CONSTRUCTION VALUE ENGINEERING CONCEPT PROPOSAL
MISSOURI DEPARTMENT OF TRANSPORTATION

**RE: V.E. PROPOSAL FOR ALTERNATE GUARD CABLE PLACEMENT
AND VEGETATIVE BARRIER
JOI0978B
ROUTE I-55
SCOTT & CAPE GIRARDEAU COUNTIES
C&H JOB NO. 10-8761-K**

Subject: VE Proposal Review
JOI0978B
Route I-55
Scott & Cape Girardeau Counties

HIGH TENSION GUARD CABLE PLACEMENT 6 : 1 AND LESS THAN 4 : 1
FLAT BOTTOM DITCH

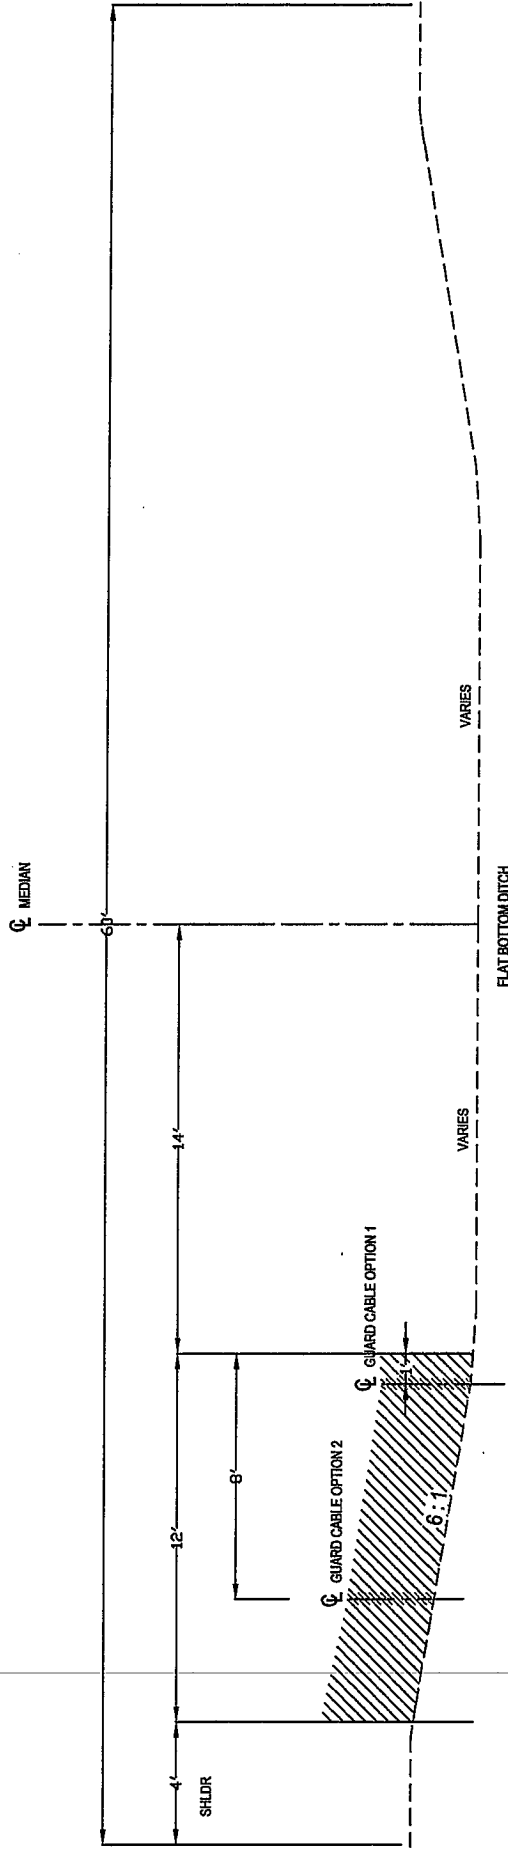
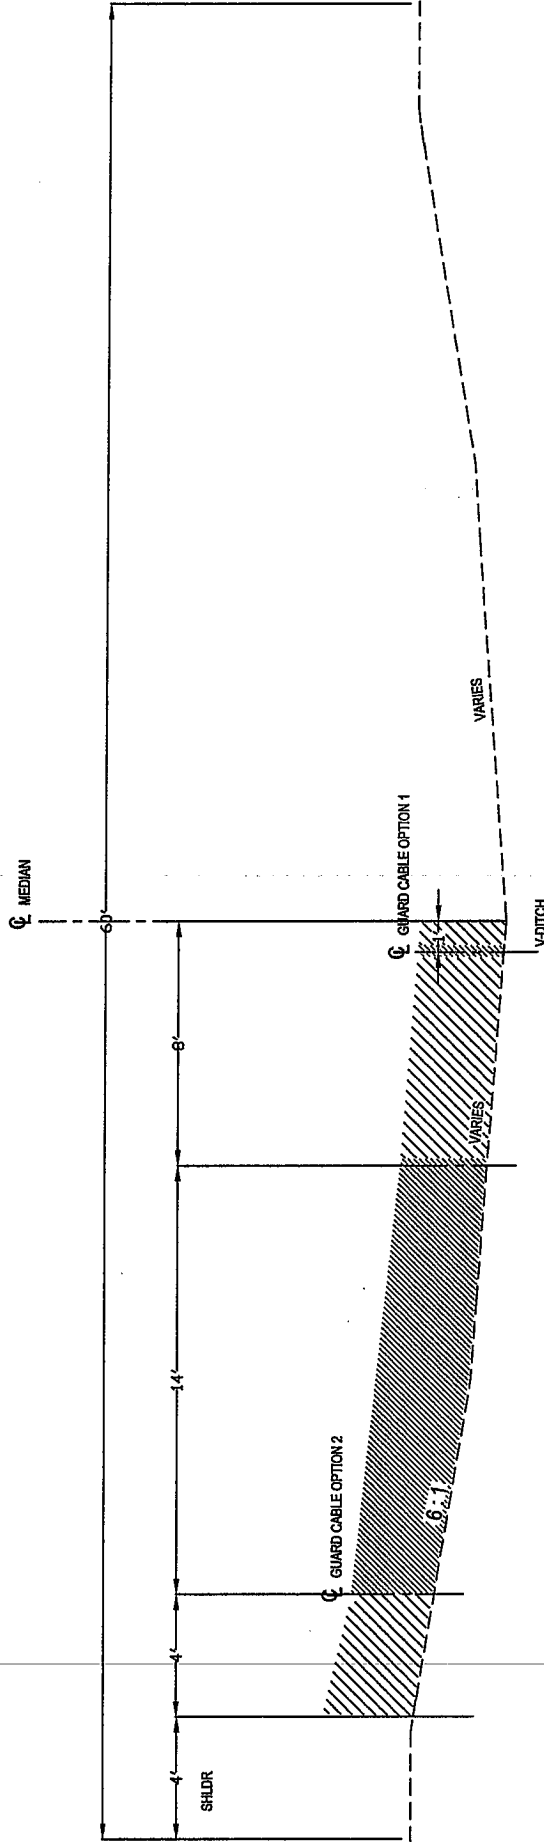
Based on our research the optimal lateral placement of the HTCB on this project, in areas where the median is 30 ft or wider and the slopes are 6 to 1 or flatter, is 1 ft up from the flat bottom ditch placing the HTCB 15' off the pavement and 11' off the existing shoulder. The installation of an 18" wide 3" thick concrete vegetative barrier along with driven sockets will provide the anchors and line post with additional lateral support over the 3" thick asphalt vegetative barrier. Placing the HTCB at this location will reduce nuisance hits and provide a safer location for maintenance personnel and the public when making repairs.

- 18" wide x 3" thick concrete vegetative barrier placed either 1' up from ditch bottom or at least 8' up from ditch bottom (see attached drawings).
- Concrete to be poured to unformed (dirt) edge with a strike off finish
- Exception is roughly a 3 mile stretch from mile marker 89 to mile marker 91. That stretch to be installed on 6' wide x 3" thick concrete due to the grade and width as shown on plan.

The offset specified in the contract is based on current FHWA testing and approval. Locations you have proposed have not been tested or approved by the FHWA, therefore, MoDOT cannot allow the placement of the post at any other location than what is specified by the contract. This is consistent with MoDOT's analysis and direction of cable median barrier and with the FHWA's test result of Gibraltar's system. In addition, there is no clear evidence that the cable will work in a location other than what is specified in the contract.

You mention that the existing grades are 6:1 or flatter. This is not the case throughout the project. The slopes are not consistent and vary any where from a 4:1 to a 6:1. In some areas, especially where the interstate has been overlaid recently, the slope with in the first few feet of the shoulder is around a 4:1 slope that transitions to a 6:1 slope. This is essentially a barn roof effect that could contribute to a vehicle leaving the ground as it departs the pavement, compressing the suspension on impact, and potentially under-riding the cable at the offsets provided in your proposal. This design issue was anticipated and addressed in the contract special provisions with the specification of a product system certified for a 4:1 slope and in the plan typical section with the specification of an offset of 4 feet from the shoulder.

HIGH TENSION GUARD CABLE PLACEMENT 4 : 1

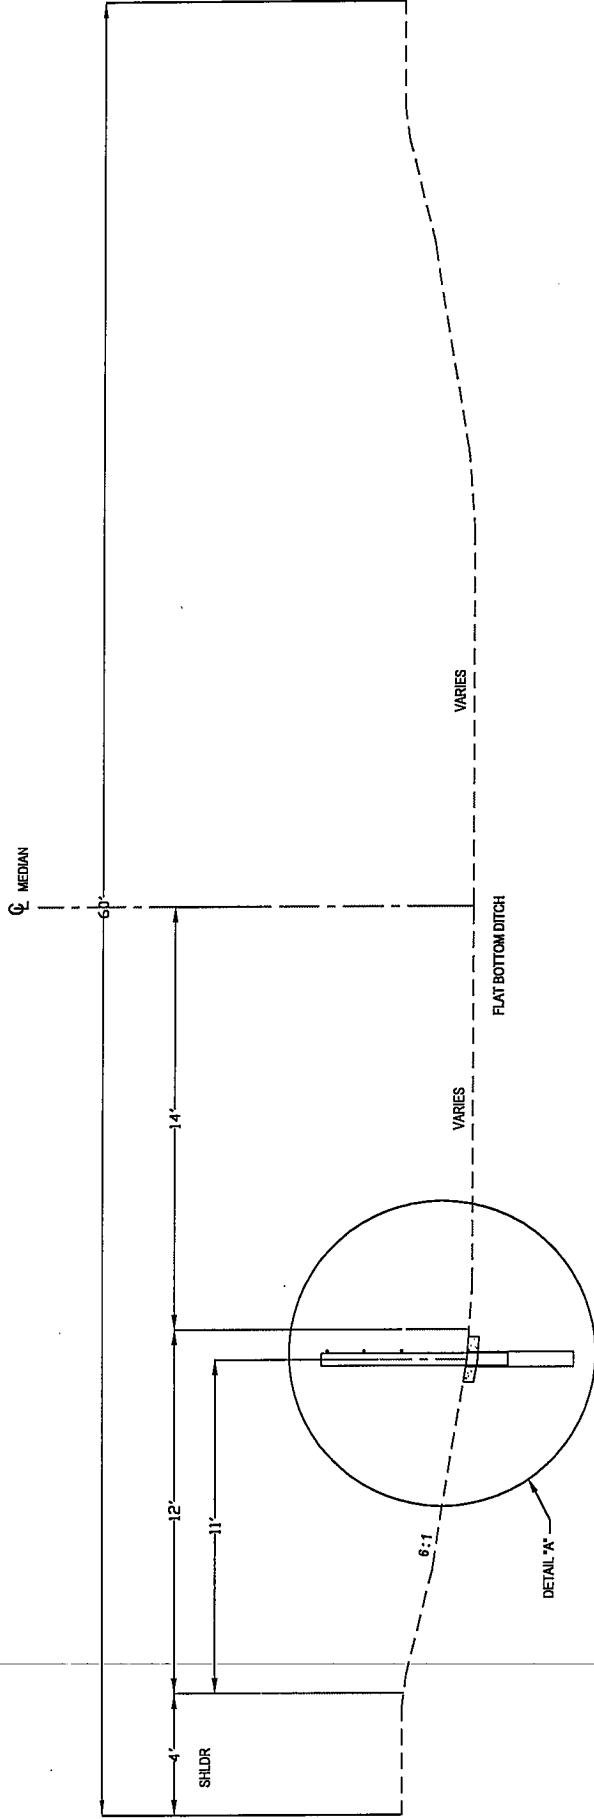
GUARD CABLE PLACEMENT 4 : 1
 NO MORE THAN 4' DOWN THE SLOPE
 DEPENDING ON SHOULDER WIDTH
 LOG MILE 88.692 - 91.376
